RESPONSE TO REQUEST FOR ADDITIONAL INFORMATION

US-APWR Design Certification

RAI NO.: NO. 709-5489 REVISION 2
SRP SECTION: 03.07.01 – Seismic Design Parameters
APPLICATION SECTION: 3.7.1
DATE OF RAI ISSUE: 03/07/11

QUESTION NO. RAI 03.07.01-13 (03.07.01-17):

Figure 1, Comparison of US-APWR CSDRS and Ground Motion from New Reactor Applications

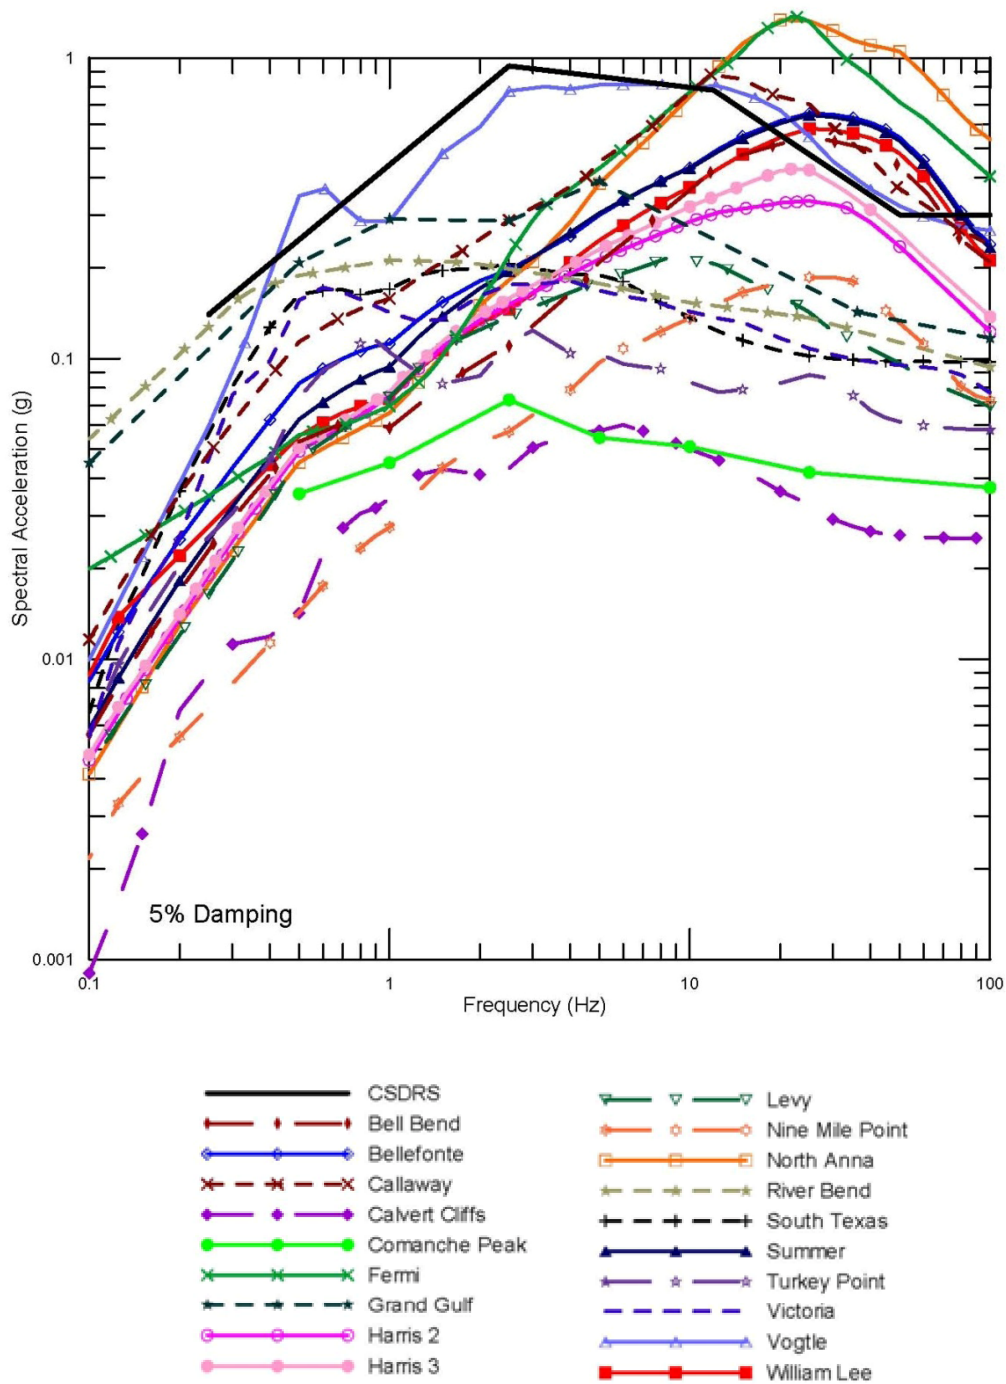
In order to determine whether the requested US-APWR standard design is usable for a multiple number of units or at a multiple number of sites in the United States without reopening or repeating the staff's review, the staff requests that MHI provide quantitative information and details of specific analyses and data developed to support its response to RAI No. 643-4967, Revision 1, (Question NO. 03.07.1-16), dated November 11, 2010, particularly regarding the two statements noted above. The staff also requests that the applicant discuss whether the analysis of the site specific variation for the hard rock sites, where the US-APWR CSDRS does and does not envelope the response spectra characteristic in the high-frequency range, will lead to site-specific variations in the plant designs among plants that reference the US-APWR design. The applicant should also discuss the extent of such variations, as appropriate.

Figure 1 provided in this response is a comparison of the US-APWR CSDRS with the publicly available ground motion for new plant applications. The graph reflects that of the 19 ground motion curves, eleven curves are bounded by the CSDRS in the high-frequency range. The ground motion for these sites therefore reflects US-APWR compliance with the definition of *Standard Design* in 10 CFR Part 52, whereby the CSDRS “is usable for a multiple number of units or at a multiple number of sites without reopening or repeating the review.” Further, DCD Section 3.7.1.1 requires the COL Applicant to perform site-specific seismic analyses [COL 3.7(22)]. The site-specific soil structure interaction (SSI) analyses may consider seismic wave

When the site-specific ground motion for natural frequencies above 10 Hz are determined to exceed the CSDRS (see Figure 1), the design of standard plant structures is not expected to change since the dominant SSI frequencies for the standard plant structures are less than 10 Hz (refer to Section 03.4.1.1 of Technical Report MUAP-10006, Rev. 3 for a summary of first-peak SSI frequencies for the R/B complex). This conclusion is made since the seismic design for these hard rock sites are bounded by the CSDRS values for natural frequencies less than 10 Hz (the low-frequency outlier is a soft soil site). Similarly, there is no impact to the core internals and fuel rods because the dominant frequencies are also less than 10 Hz. Therefore, the seismic design for the standard plant structures, the core internals and fuel rods are not affected for hard rock sites in CEUS.
